UNITED STATES PATENT AND TRADEMARK OFFICE

APPLICATION NO.	FILING DATE	FIRST NAMED INVENTOR	ATTORNEY DOCKET NO.	CONFIRMATION NO.
10/027,418	12/19/2001	Himanshu Patel	018489-002510US	2779
20350 7590 03/31/2008 TOWNSEND AND TOWNSEND AND CREW, LLP TWO EMBARCADERO CENTER EIGHTH FLOOR SAN FRANCISCO, CA 94111-3834				
EXAMINER ERIZO, DARWIN P				
ART UNIT		PAPER NUMBER		
3773				
MAIL DATE		DELIVERY MODE		
03/31/2008		PAPER

Office Action Summary

DETAILED ACTION

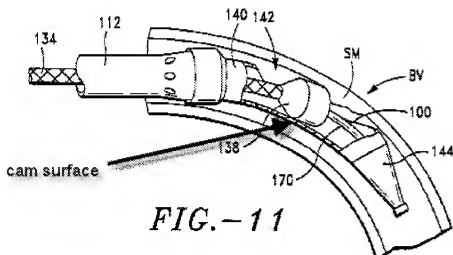
(claim 39) In Fig. 11, Hundertmark discloses a method of removing material (atherectomy) comprising the steps of: delivering a catheter having a tissue debulking device or cutter **138**; deflecting a distal portion of the catheter to a proximal portion of the catheter to expose the cutter, wherein the proximal movement of the catheter through a tortuous blood vessel causes the deflection against an inner cam surface of the catheter (see attached Fig. 11); and debulking the body lumen by rotating the cutter about an axis to expose the cutter through a cutting window **142**.

Hundertmark is silent with regards to the step of advancing the catheter in the body lumen to move the rotating tissue debulking device and cutting window through material in the body lumen during the deflecting step. However, the operation of the device shown in Fig. 11 clearly shows a device that is not secured to the region of stenosis since the tortuous passageway of the blood vessel will urge the distal end of the catheter to deflect and cause the cutter to be exposed from the cutting windows. As shown in the figure, the inflatable portion of the catheter is not inflated. Therefore, the device of Hundertmark is capable of being moved through the body lumen of the blood vessel during the cutting process.

It is also noted that the inner surface of the catheter adjacent the location of the cutter acts as a cam surface when the distal end of the catheter is deflected, as shown in Fig. 11.

As to claim 42, Hundertmark teaches the cutter rotating about the longitudinal axis of the catheter (Fig. 12).

As to claim 44, Hundertmark teaches a hollow nose cone **144** for packing or storing the severed material.

As to claims 45 and 48, Hundertmark teaches the deflection of the catheter occurring when the catheter is in a curved region of a blood vessel and the cutter is being urged against the tissue to be cut (moving the cutter from one position to the next position can occur simultaneously with the movement of the catheter).

As to claim 46, Hundertmark discloses a guidewire **146**.

As to claims 62, 69-72 and 74-76, Hundertmark discloses a method of debulking a body lumen comprising the steps of: providing a catheter having a rotating cutter **138**, a collection chamber **144**; a cutting window **142**; the cutter having a stored and exposed position (Fig. 10 or 1 and Fig. 11, respectively); wherein the cutter would be in the stored position prior to being placed within the body lumen; wherein the catheter has means for rotating the cutter (col. 7, lines 17-20); exposing the cutter (Fig. 11); advancing the catheter to remove occlusive material while rotating the cutter (inherent in the operation of an atherectomy device); wherein the window is a side opening in the catheter; and wherein the a drive shaft is connected to spline **130**, which is then connected to a motor drive unit. It is also noted that the device is fully capable of maintaining its orientation if moved along a constant curved body lumen, as seen in Fig. 11. The modification to include the step of advancing the device through the occlusive material while the cutter is exposed is provided in the rejections to claim 39.
